CITY OF SNOHOMISH

NOTICE OF REGULAR MEETING DESIGN REVIEW BOARD

DESIGN REVIEW BOARD STAFF REPORT

Design Review Number:	20-15-DRB	Meeting Date:	September 9, 2020
Applicant:	Andrea Contenta		
Property Address:	329 Avenue B		
Application Date:	August 31, 2020		
Project Description:	Rear porch covering and window modifications		
Land Use Designation:	Single Family	Requested Review:	<i>Detailed</i>
Compliance with Title 14:	No land use issues have been identified.

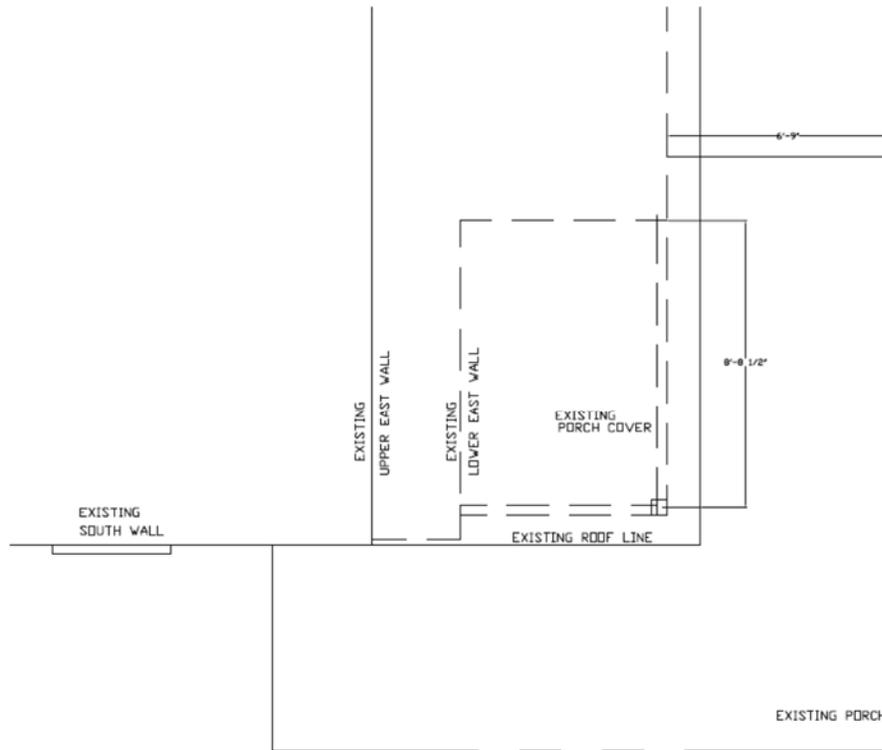
Proposed side windows will match this one (on the front of the home)

Support posts for porch roof will be custom milled to match these (found throughout the home)

Roof covering proposed in this area. New support post will match existing.

PLAN VIEW

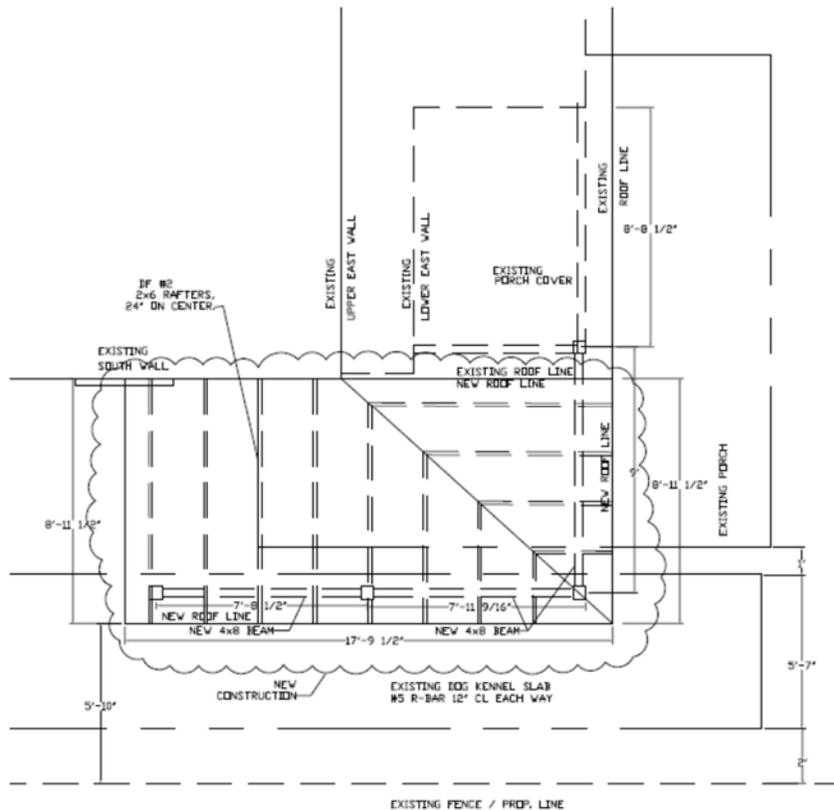
Existing porch shown above is presently uncovered; the proposal would extend the roof over this area as shown below.

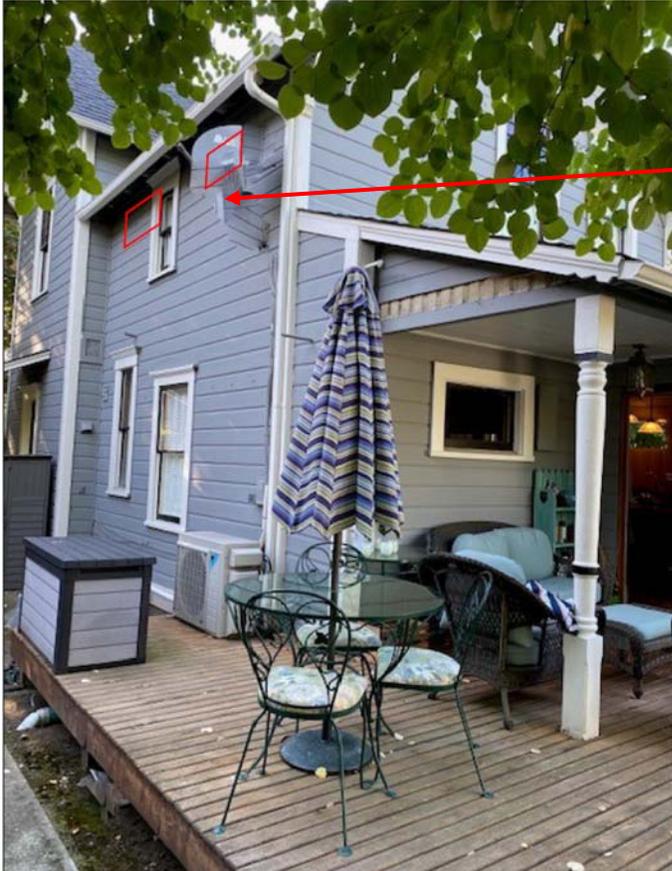
Century Porch Post Inc. uses only select clear pine lumber as opposed to the lower construction grade knotty pine. Knots will bleed through finished paintwork.

According to the website, Century Porch Post is a woodturning company that offers custom mill work. The applicant selected this company because they can customize the new support posts to match the existing posts on the home.

ELEVATION LOOKING NORTH

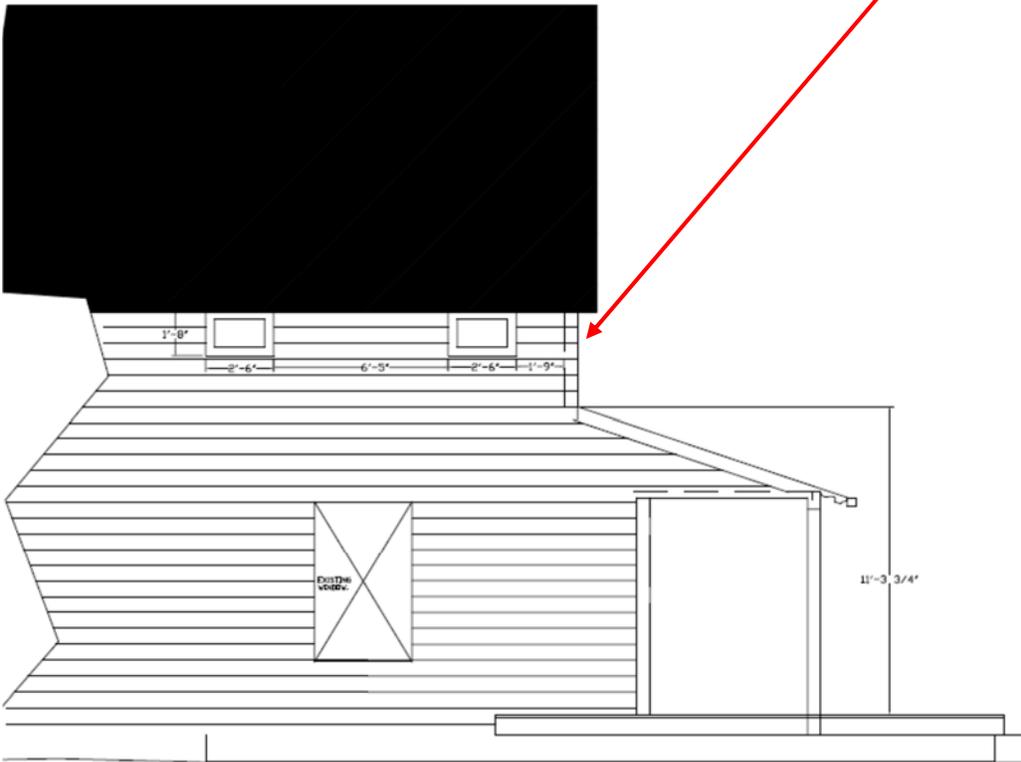
Two new windows proposed, designed to match the window on the front of the home (page 8). One window will replace the existing vertically oriented window shown.

Proposed windows measure appx 1'10" wide by 1 foot in height. Shown here with trim at 2'6" wide by 1'8" in height.
